PROPOSED DCPRS CERTIFICATION CHANGES

DCS MANUFACTURERS MEETING
MARCH 22/23 2004

PROPOSED ALLOCATIONS WITHIN A 300 BPS CHANNEL

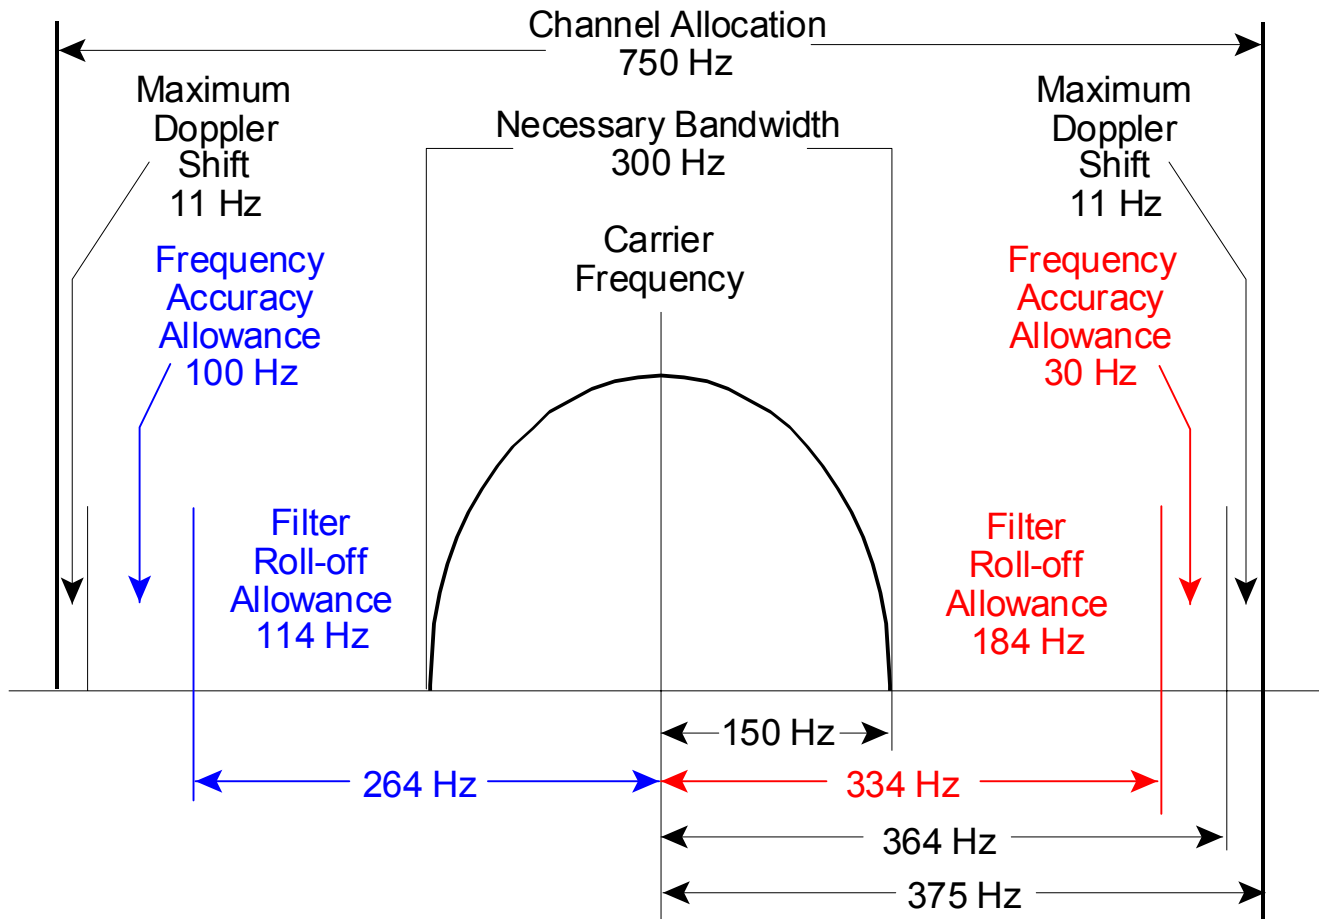
- Proposed change is from ± 425 to ± 30 Hz
- Not expected to be a problem if GPS used to discipline local oscillator, but GPS antenna can become obstructed
- Is a back-up method needed? (DCPI?)
- Should extra variation be permitted for short periods, e.g., up to 24 hours?

PHASE NOISE (2)

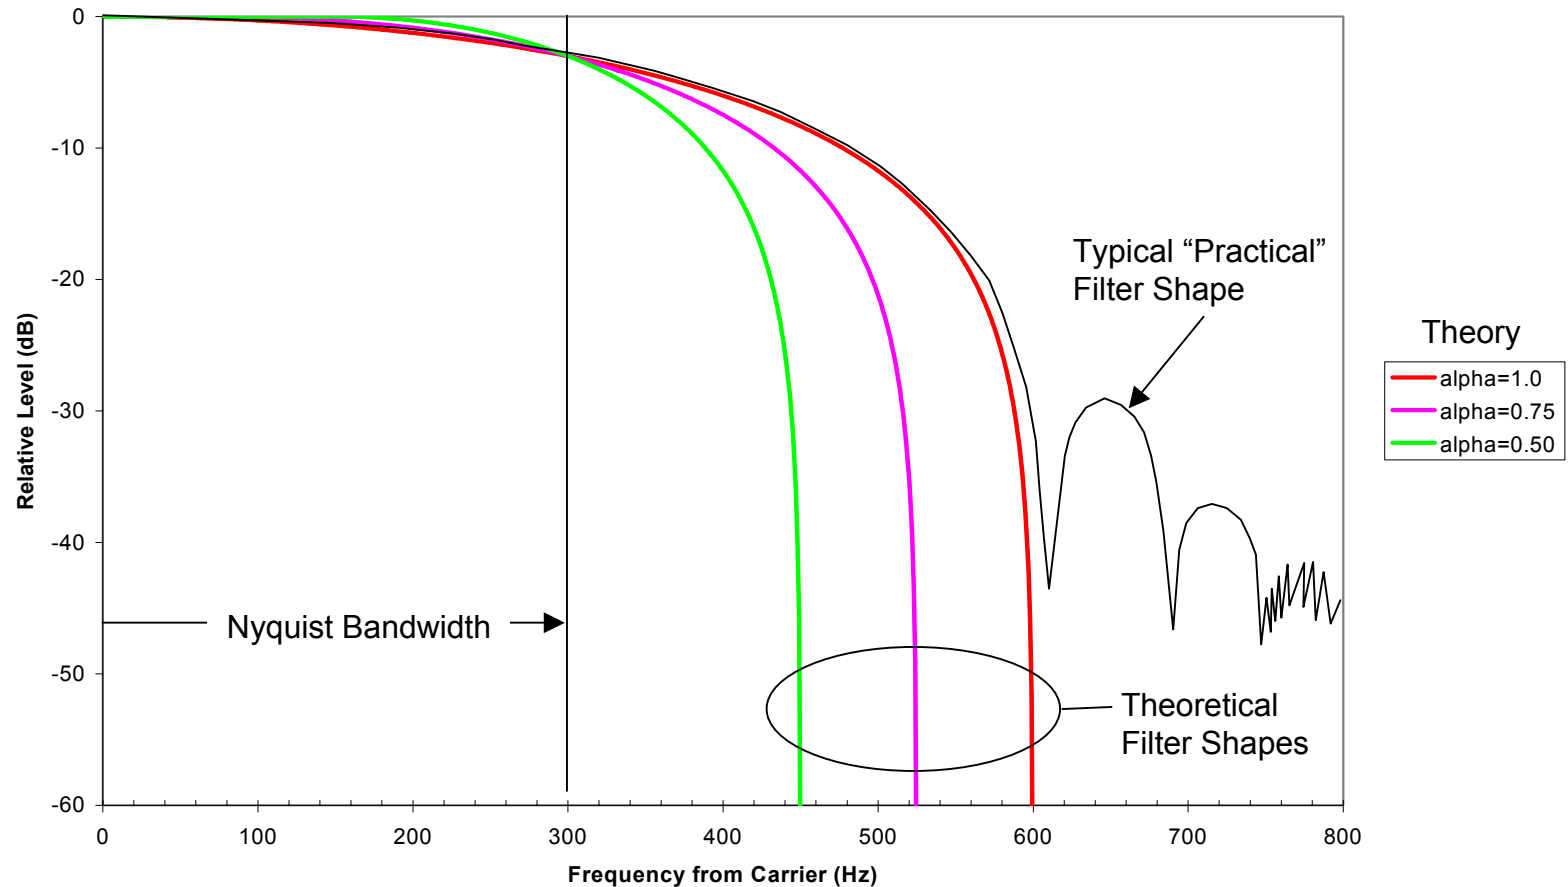
- Change to one Phase Noise requirement (including bias or offset in the modulator)
- Requirement reduced to 3.0 degrees RMS
- Oscillator phase noise only relevant from demodulator tracking loop bandwidth to frequency of first sideband null
 - 10 Hz to 150 Hz for 300 bps
 - 36 Hz to 600 Hz for 1200 bps

- Changes are intended to
 - Test only for the required parameter
 - Make the test result easy to acquire
 - Make transmitter requirement compatible with overall phase noise budget for the links
 - $T_x = 2.5$, $Sat = 1.0$, $CDA = 2.0 + 1.0$
- Proposed subsection refers to Appendix E
 - Appendix E has not been revised
 - Suggestions?
